Ref: FCC Class II Permissive change for FCC ID: **SPYIM0002**
Original Grant Date: 07/28/2016
Applicant: Bitatek Co., Ltd.

This is to request a Class II permissive change for FCC ID: **SPYIM0002**
, originally granted on 07/28/2016

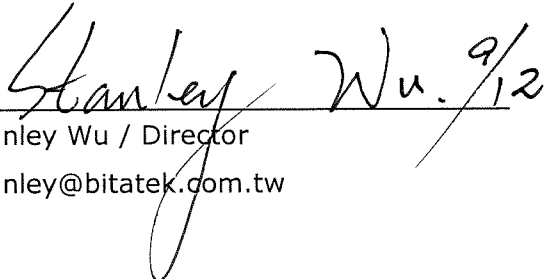
The major change filed under this application is:

1. The subject approved module is being used in a host (Portable category configuration,
Brand name/Model: see test report.)
2. The difference compared with the original design is adding 2 antennas to this EUT:

IFA Antenna,

Maximum Gain: 2.0 dBi at 2.4GHz ; 2.9 dBi at 5GHz.
